BULLETIN NUMBER 04-061315

SUBJECT: ROLLBACK DETECTION

Roll Back Detection Kit Mounted on Borvig Lift

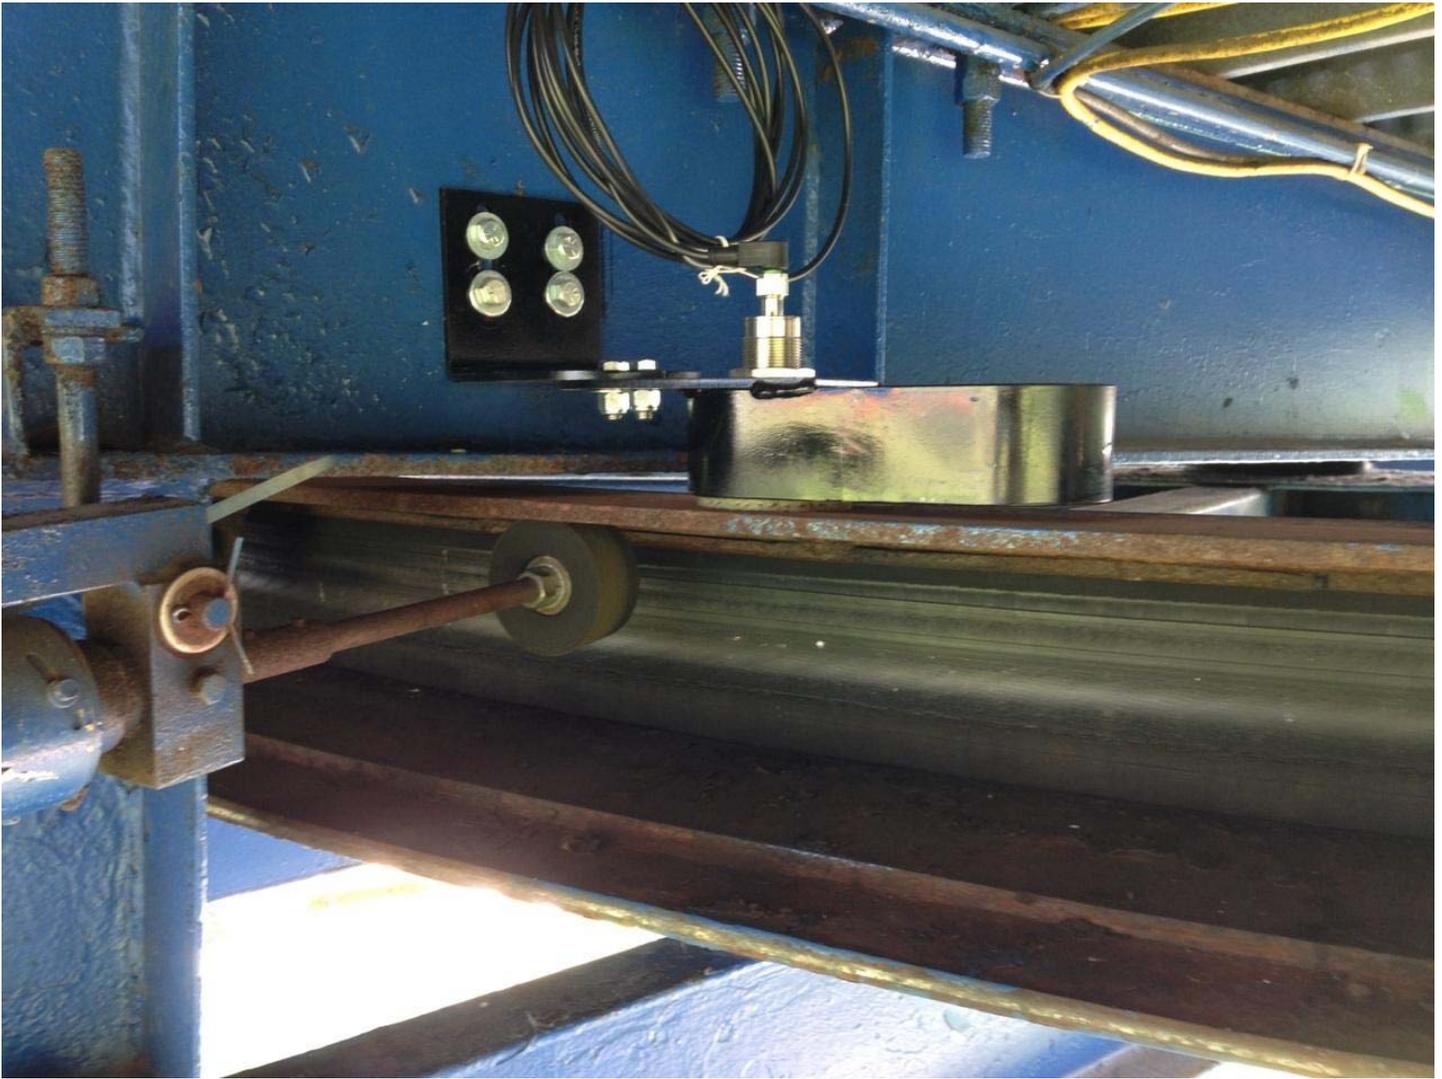
Partek has developed an easily fitted system to enhance safety on **Borvig** lifts. This system is designed to detect a roll back within 3 inches of reverse rotation. A relay is supplied that will remove power from the bull wheel backstop solenoid and initiate an emergency stop in the lift control circuit. This enhancement is required for all Borvig lifts that do not currently have such a system in place. A wiring schematic will be provided with each kit and must be installed, wired and tested for functionality by qualified personnel.
